Reliable Energy, Inc.'s (REI) Comments on CenterPoint Energy Indiana South's (CEI South's) Integrated Resource Plan (IRP)

September 28, 2023

Exhibit 2

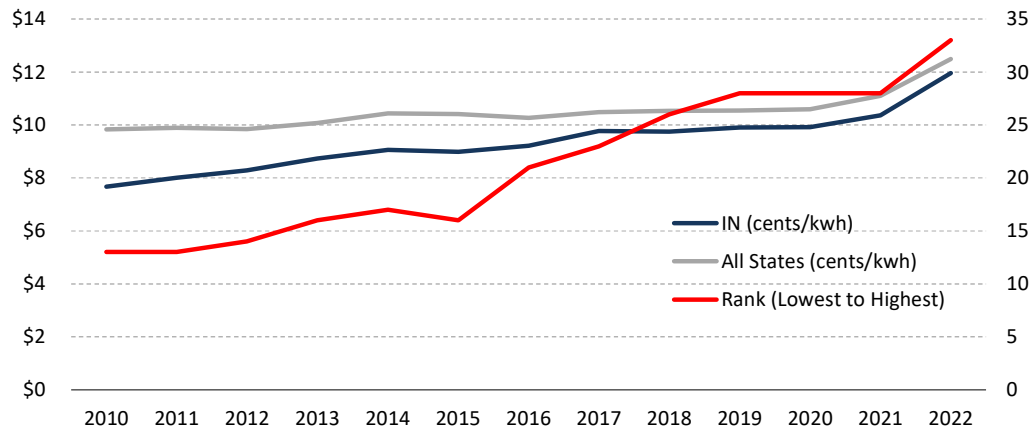
For obvious reasons, power rates are an important determinant of desirability of location for businesses. As shown in Exhibit 2, Indiana’s power rates have increased at a greater pace than All States and its ranking has significantly worsened.

Exhibit 4

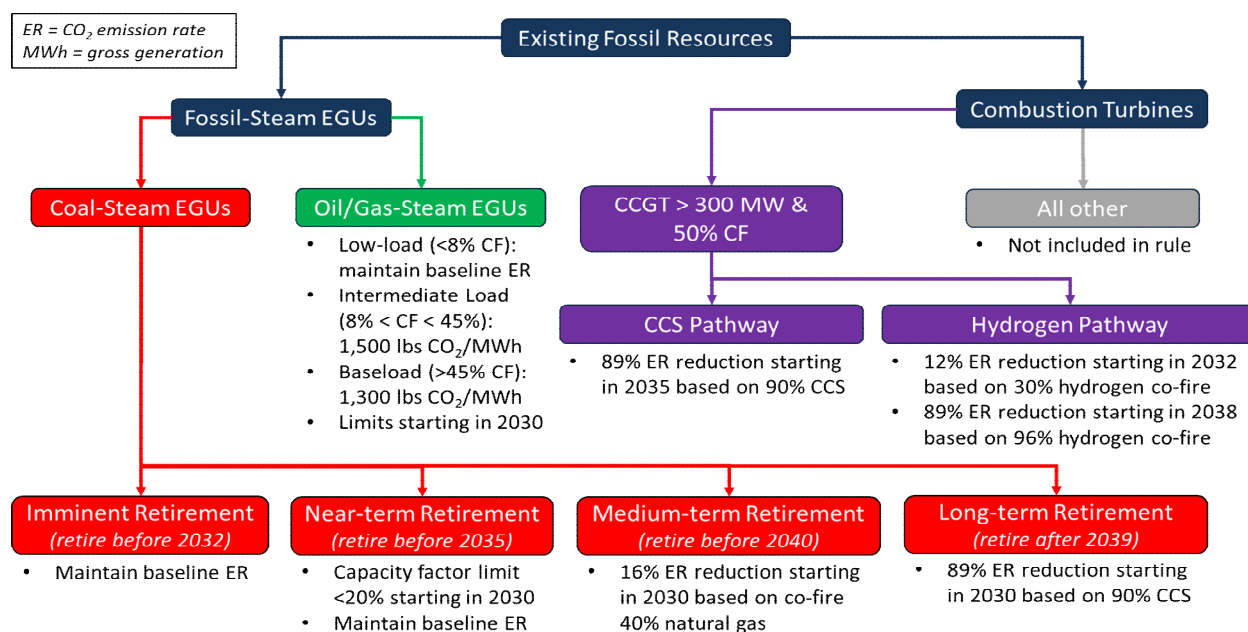
Section 111(d)'s requirements for existing fossil plants are displayed in Exhibit 4. Existing coal plants have no compliance requirements if they retire by 2032. If not retired, existing oil/steam gas plants' requirements are tied to the capacity factor beginning in 2030. *In other words, no actions are required in this decade.* Thereafter, emission rates are set for the plants based upon load and, in the case of coal plants, retirement dates.

There is no basis in the interim for making commitments to close and/or convert Culley Unit 3 as the final rule will no doubt have differences with the proposed rule. Clearly, if the requirement to close Culley Unit 3 is the same as proposed for coal and natural gas in the final rule, there would be no reason to convert Culley Unit 3 to gas.
